SUBJECT: Requests mod of subj facil Environ Tech Specs per 770801 ltr proposal.
Changes cover Section 3.1.B.e-Water Quality & Section 5.0-Administrative Controls & are administrative in nature. W/encl proposed mods.

September 29, 1978
L-78-314

Re: St. Lucie Unit No. 1
Docket Nos. 50-335
Revision to Environmental Technical Specifications
Operating License DPR-67

FLORIDA POWER & LIGHT COMPANY
 CORPORATE ORGANIZATION - ENVIRONMENTAL AFFAIRS
 FIGURE 5.2-1

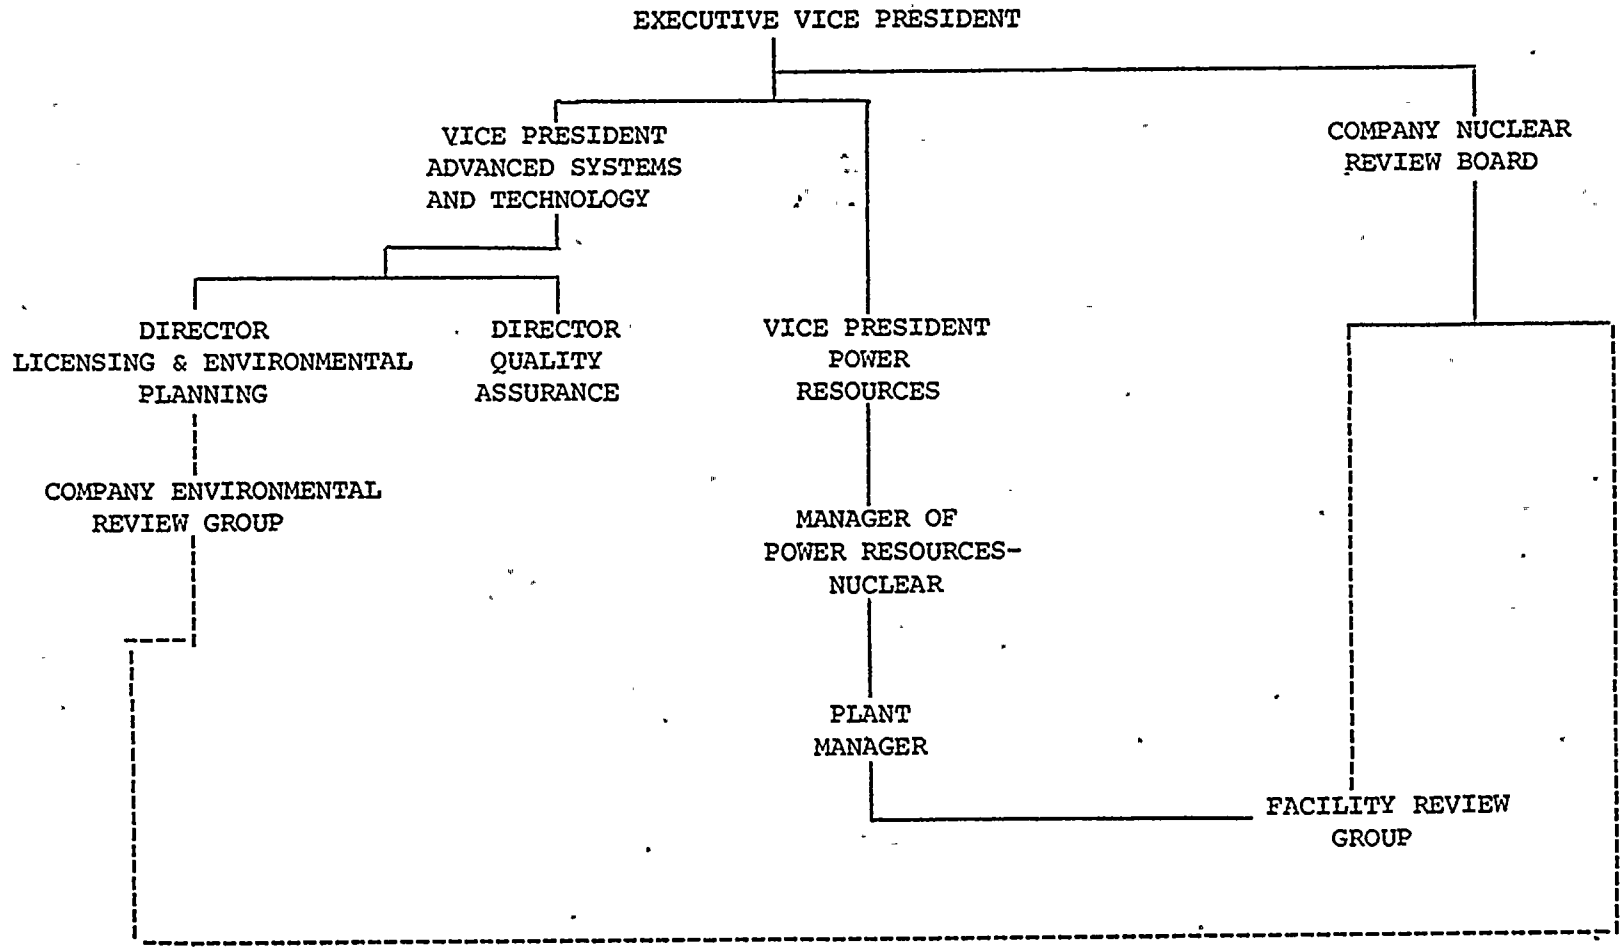
This request supplements our proposed ETS changes submitted by letter dated August 1, 1977, (L-77-244). Pages 5-1, 5-2, 5-3, and 5-4 contain changes to Section 5.0, "Administrative Controls," which reflect individual title changes and department name changes, and replace the respective pages contained in our previous submittal in their entirety. Also included is a proposed change to Section 3.1.B.e, "Water Quality," which is described below. All of the changes are shown on the attached revised ETS pages bearing the date of this letter in the lower right hand corner.

The corporate organization involved in environmental matters is depicted in Figure 5.2-1.
